Subject: FW: Part 150 Study and FAA Operational Nighttime Procedure Issues
Attachments: Document.docx
Importance: High

Part 150 Issues

Attempt by FAA to formalize nighttime departure

Figure 1 Title 21 Q2 65 dB CNEL contour

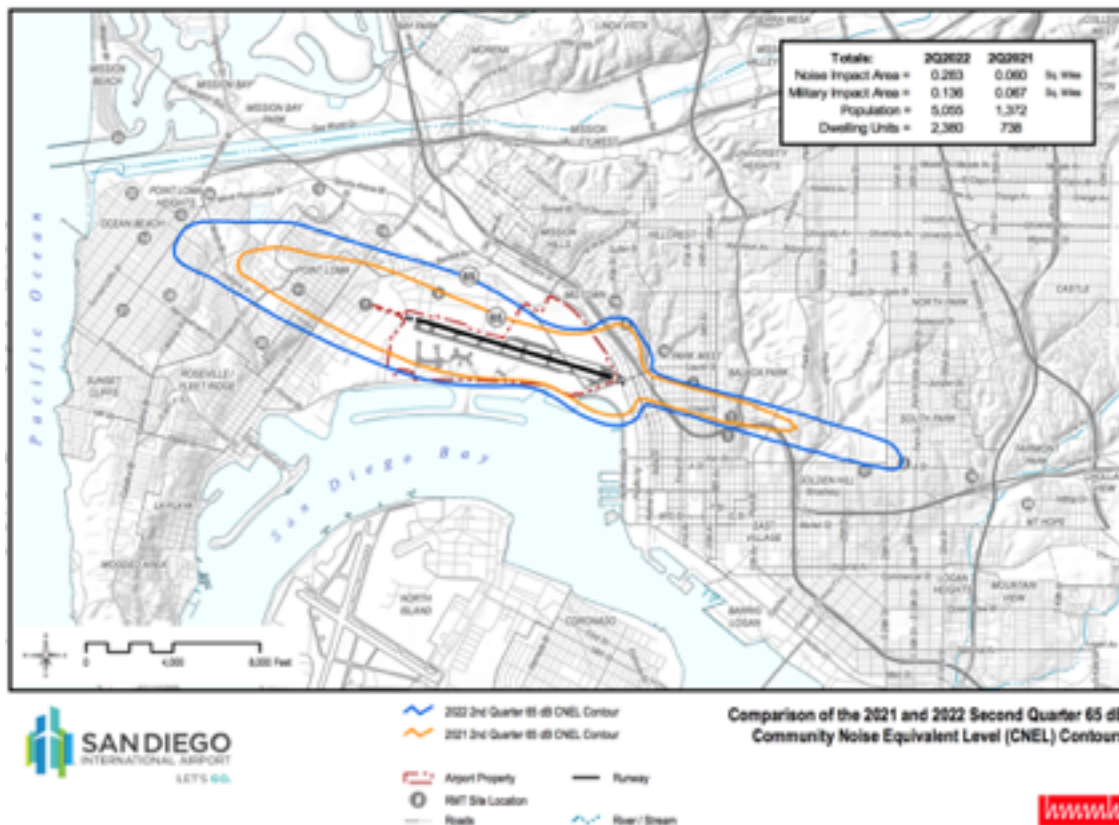
I reviewed the Title 21 Q2 report for 2022 and found some new language not in previous reports (see underlined sentences in *italics*). Personnel in the noise mitigation office admitted that they had not used the noise monitoring system previously even though the State of California required this system to be used. While the language in the report implies the NMS was used to potentially adjust the 65 dB CNEL contour development (see Figure 1), there is no description of how it was used.

As I have mentioned previously, my analyses showed that the Part 150 Study incorrectly published a 65 dB CNEL that is too small by one square mile. This is compared to the 65 dB CNEL that was published in the 2018 Title 21 report. The data in Table 2 identifies what is believed to be the explanation for the disparity in the 22:00-6:59 column. The 11.1 operations for the Part 150 study baseline contour is completely inconsistent with all of the other data shown. Perhaps the Airport Authority can provide an explanation.

Figure 4 Summary of noise data measured using Larson Davis LxT

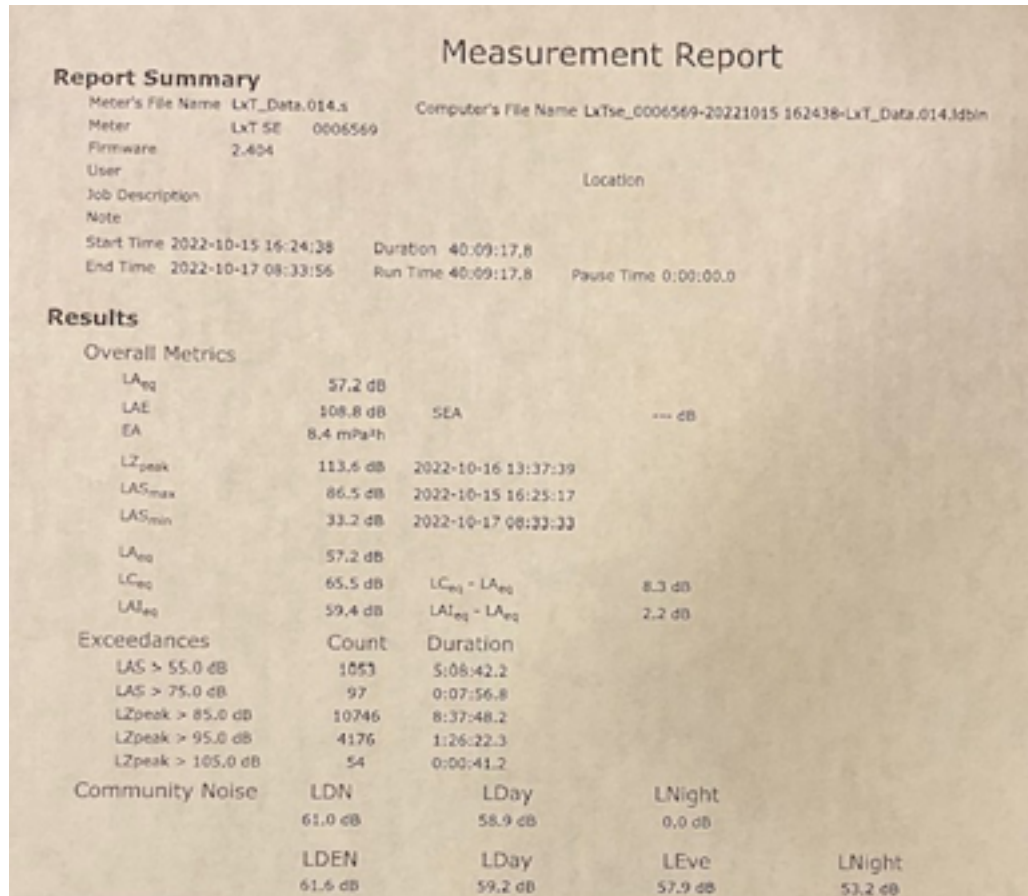
Lastly, I set up my Larson Davis portable noise measurement device, LxT model and made measurements on my 3rd story deck for a little more than 40 hours. The community noise levels are summarized in Figure 4. Note the community noise level values for day, evening and night. The fact that the measured values are so large raises into question the validity of the 65

dB CNEL noise contour. More study will be required of the night value to understand why it is so small. Also, I believe the aircraft tags in Webtraks use to show the aircraft type, but no more. Now this very useful piece of information has been replaced by the tail number. If anything, both the aircraft type and the tail number should be included.

Figure 1 2022 Q2 Title 21 65 dB CNEL

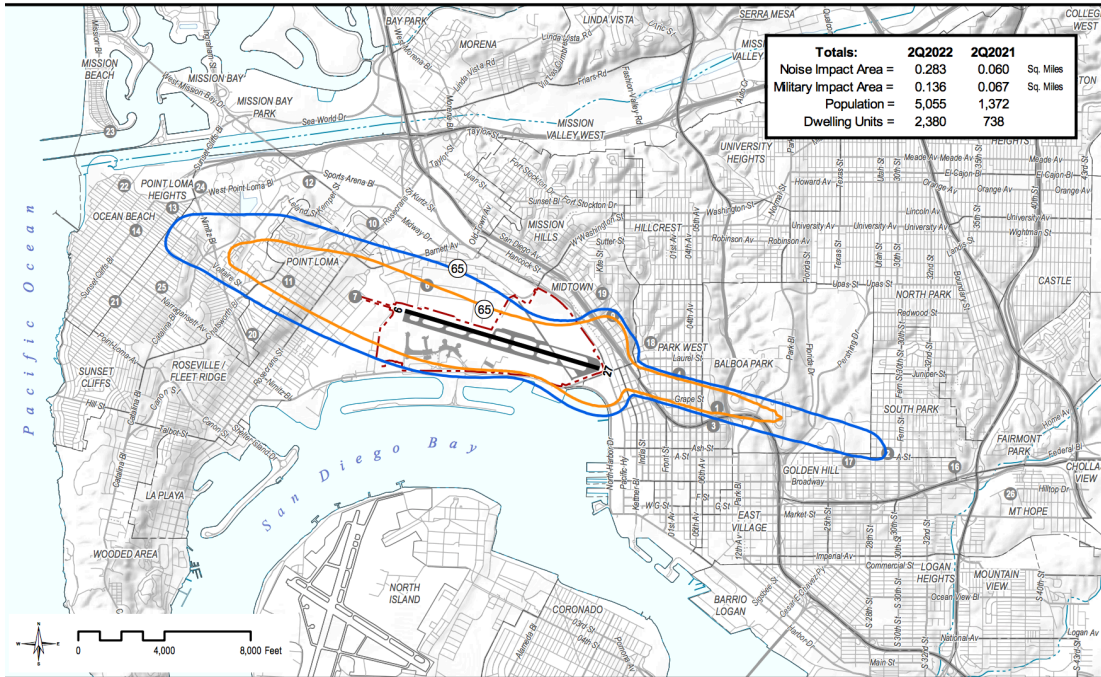
I have also included below the 65 dB CNEL from the Title 21 report. I used Sketch and Calc to calculate the area of the whole contour in Figure 1 at 3.88 square miles. I used a variety of data from the Title 21 report and the FAA AEM software to calculate the values of CNEL at each of the noise monitors, which were then compared to the measured noise monitor values. The input data and the results are shown in Table 1.

I used the methodology we developed in the student study last academic year to, first quantify the CNEL values at the noise monitor locations and then estimate the effect of the differences on the 65 dB area. I only performed this assessment for the noise monitors to the west of the runway. Based on this limited assessment, I found that that noise monitors to the southwest, 21, 25, and 20 indicate that the contour is too large in this area and that the noise monitors 7 and 11 indicate that the contour is too small in this area due west of the runway. The rest of the noise monitors were reasonably close.

Figure 4 Early morning data (6:30 to 7 am) collected on Avalon Court on 10/16/2022

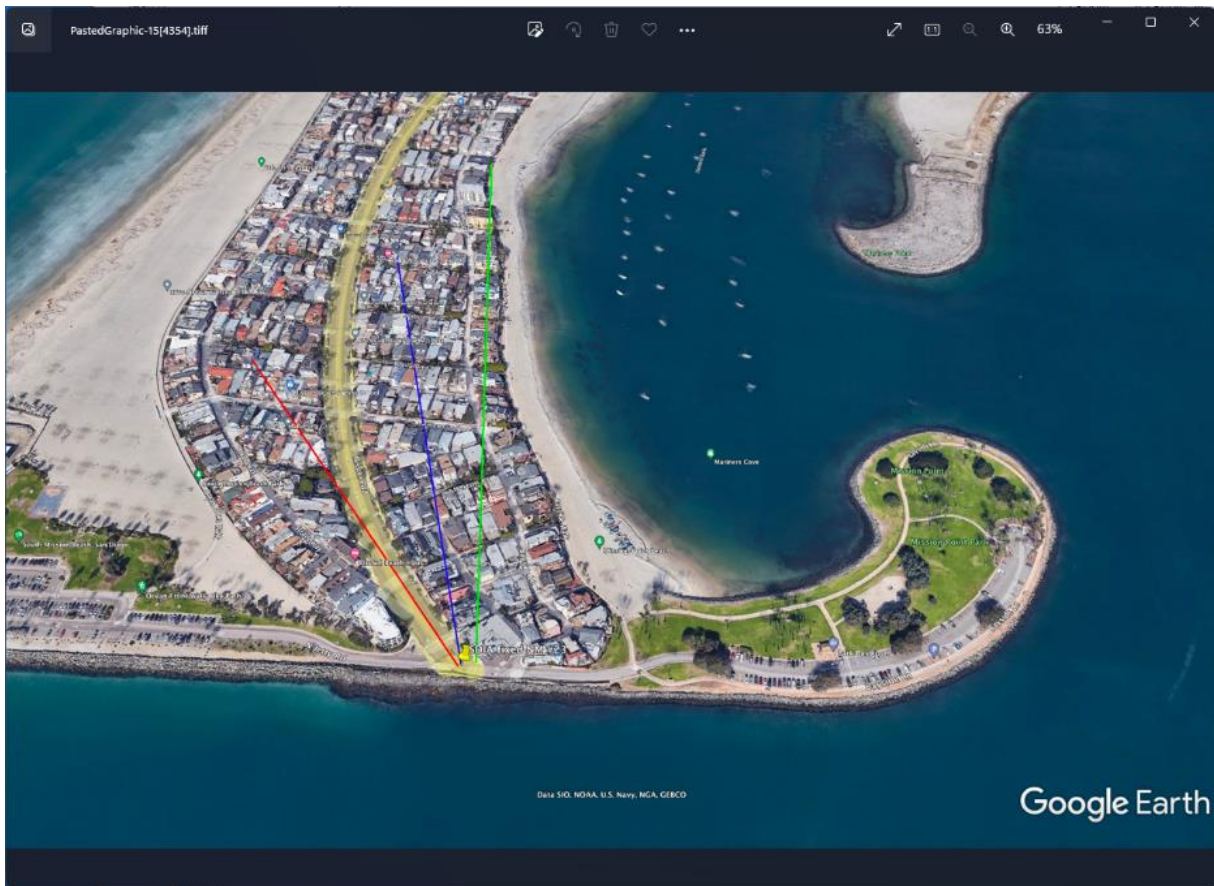
Figure 4 is an output from the Larson Davis portable noise monitor located on Avalon Court covering the time period from 6:30 am to 7 am on October 16. There are 18 departures with six on ZZOOO and the rest on PADRZ. Note that the departures on PADRZ are all very loud with a number of the peaks exceeding 70 dB (Lasmax only). But in any case, there is little to no respite, except when there is/are arrival(s).

The Lasmax data between the LxT and Webtrax NM#23 is directly compared in Table 1. As can be seen, the LxT measurements consistently exceed the NM#23 for the PADRZ departures, but are less than NM#23 for the ZZOOO departures. There are two possible explanations for the lower values for the ZZOOO departures. The LxT monitor is between 900 and 1,000 feet farther from the aircraft compared to the NM#23 for the ZZOOO departures, but it is also possible that the third story structure partially blocked sound for the LxT monitor.

Figure 5 Comparison of 11/2 early morning departures at Brighton Court (green line) and NM#23 Lmax noise values; time history is from LxT

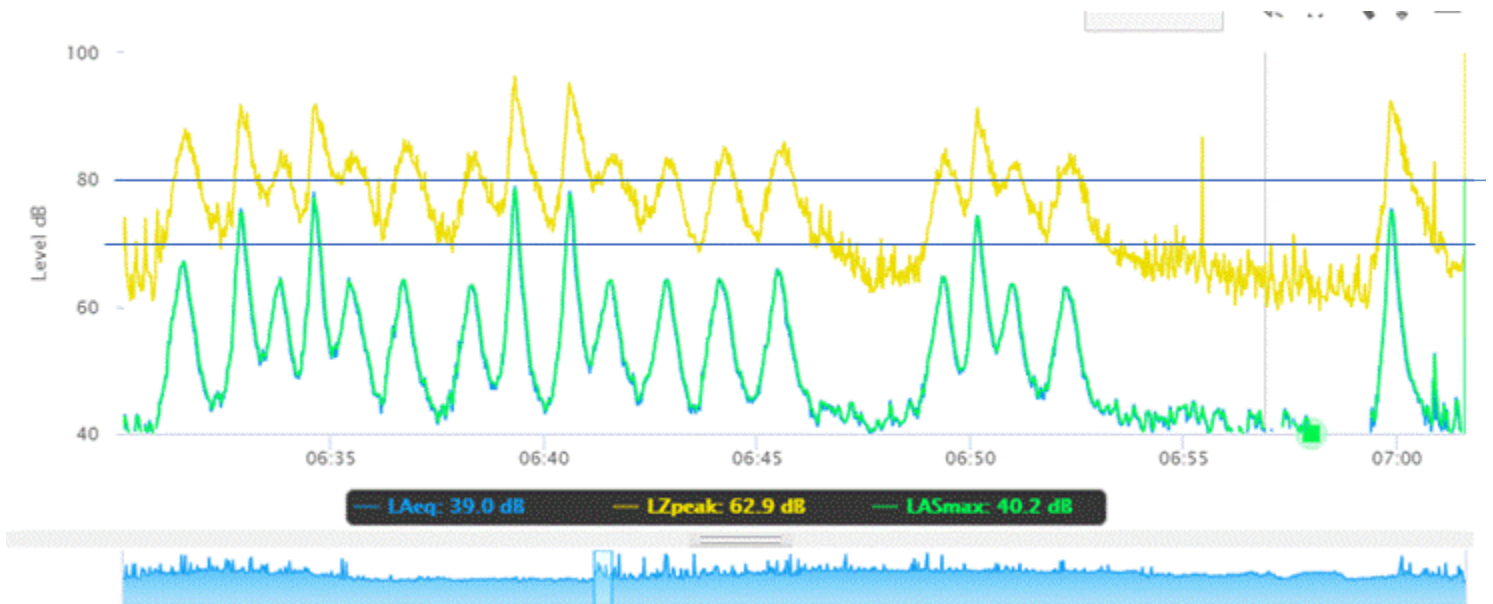
A similar assessment was performed for the LxT located on Brighton Court. The picture in Figure 5 shows time history data for the LxT data from the Larson Davis portable noise monitor for, 6:30 to 7 am and 10 to 11:30 pm, the first one on October 16th at Avalon location and the second one on October 31 at Brighton. Mission Beach has one noise monitor located at the jetty at the most southern end of Mission Blvd. At one point, Mission Beach had four monitors, but as the 65 dB CNEL receded, monitors were removed on the pretext that the noise levels could not be distinguished from ambient noise. So, I am making a series of noise measurements to observe the noise levels as the portable monitor is moved north to determine at what point the aircraft noise is the same as other environmental noise. For the two locations measured north of the jetty, the noise levels are very comparable to the fixed NM#23.

It is fair to conclude from the data presented and the analysis comparisons that the noise levels on Avalon Court and Brighton Court are at least as loud as at the jetty. Noise monitors are omni-directional; that is they do not differentiate between noise north or south of the monitor. Given that the noise levels are at least as loud at the two locations where measurements were made by the LxT, then I would conclude that the NM#23 is not adequate by itself in the calculation of the 65 dB CNEL. We can therefore conclude that additional noise monitors are required to the north of NM#23 to more accurately characterize the noise in SMB.
